# dsPIC33FJ06GS001/101A/102A/202A and dsPIC33FJ09GS302

## dsPIC33FJ06GS001/101A/102A/202A and dsPIC33FJ09GS302 Family Silicon Errata and Data Sheet Clarification

The dsPIC33FJ06GS001/101A/102A/202A and dsPIC33FJ09GS302 family devices that you have received conform functionally to the current Device Data Sheet (DS75018C), except for the anomalies described in this document.

**FIGURE 19-2: ADC BLOCK DIAGRAM FOR THE dsPIC33FJ06GS101A DEVICE**

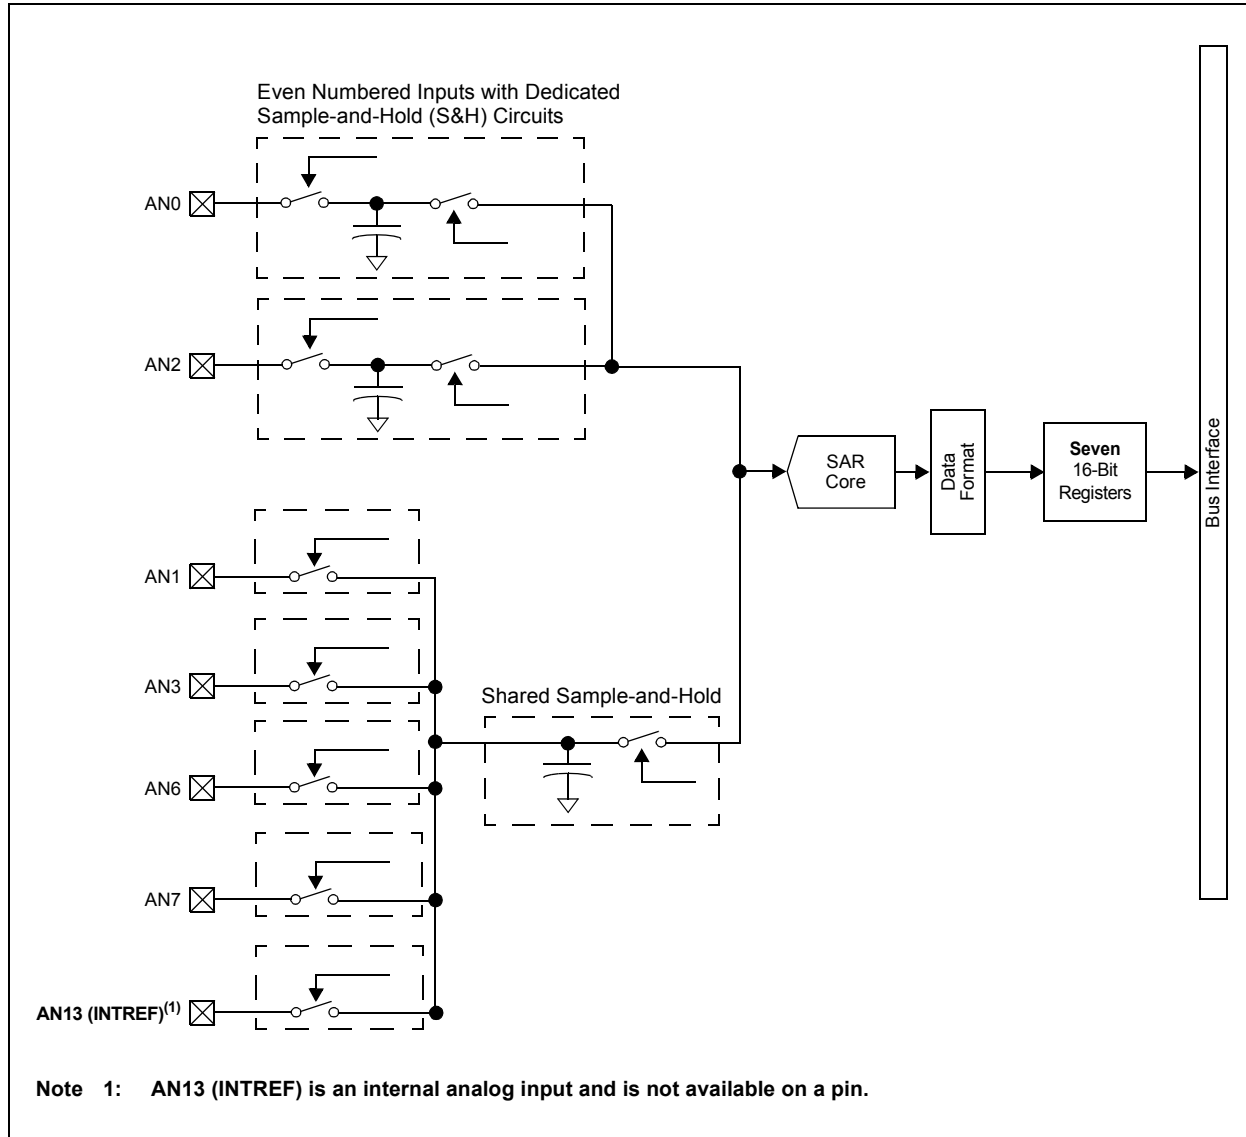
In Figure 19-2 and Figure 19-3, AN13 has been added and the number of output registers has been changed from eight to seven.

FIGURE 19-5: ADC BLOCK DIAGRAM FOR THE dsPIC33FJ09GS302 DEVICE

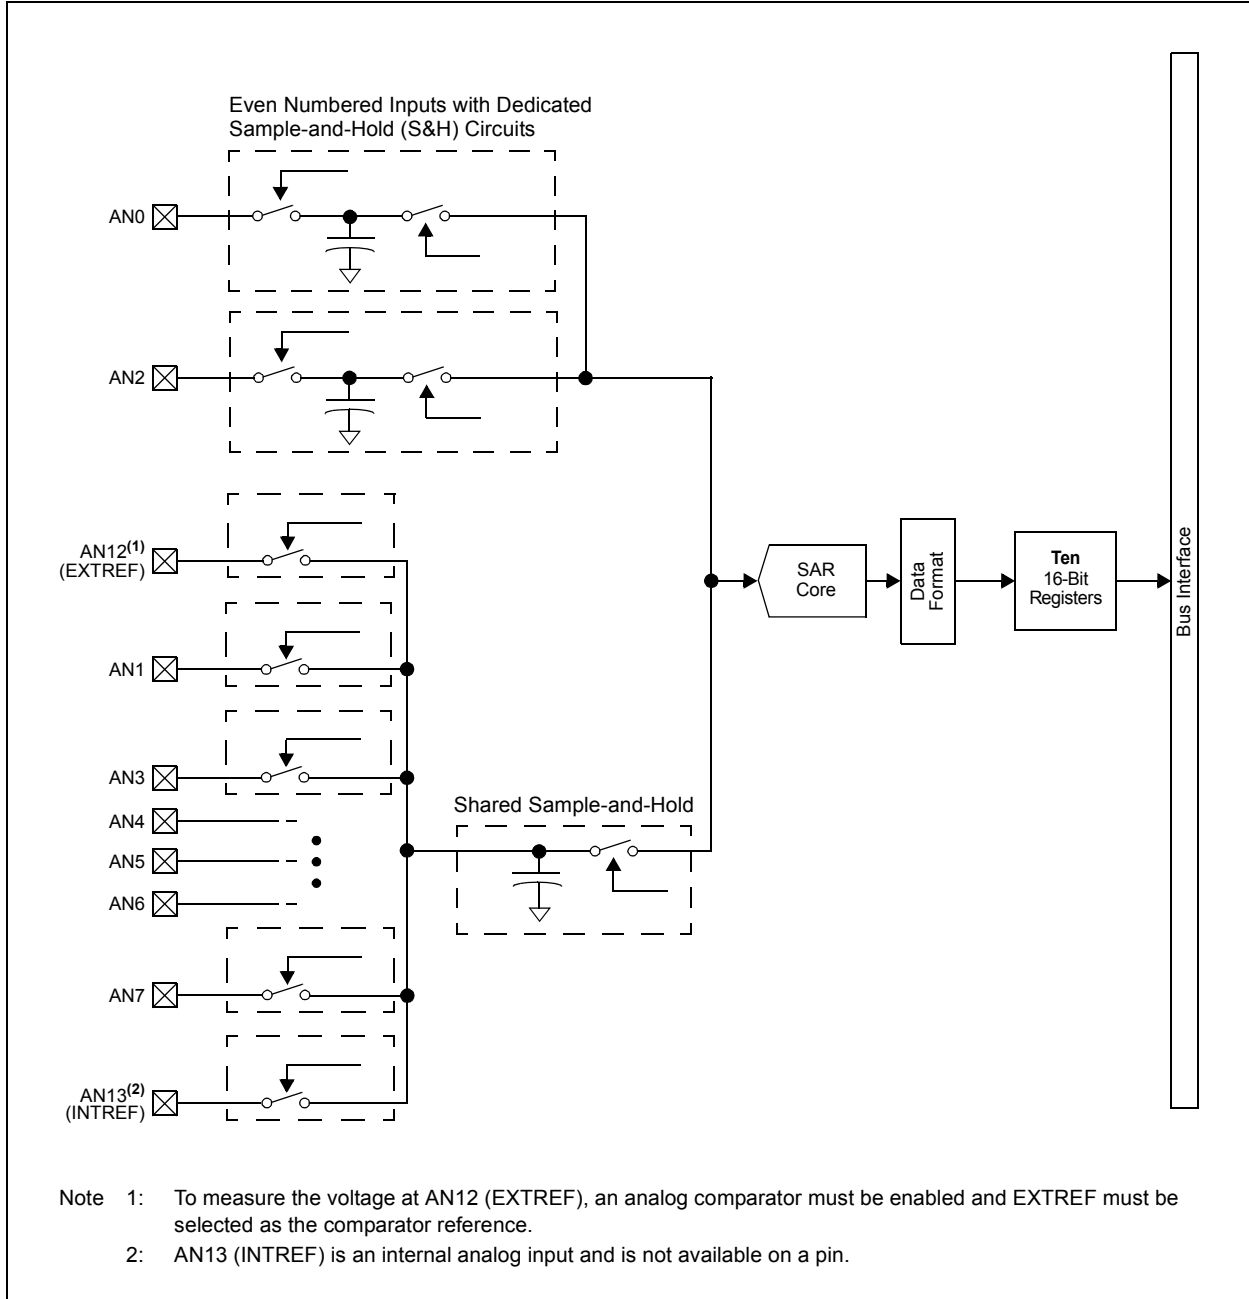
In Figure 19-5, the number of output registers has been changed from eight to ten. The changes are shown in bold below:
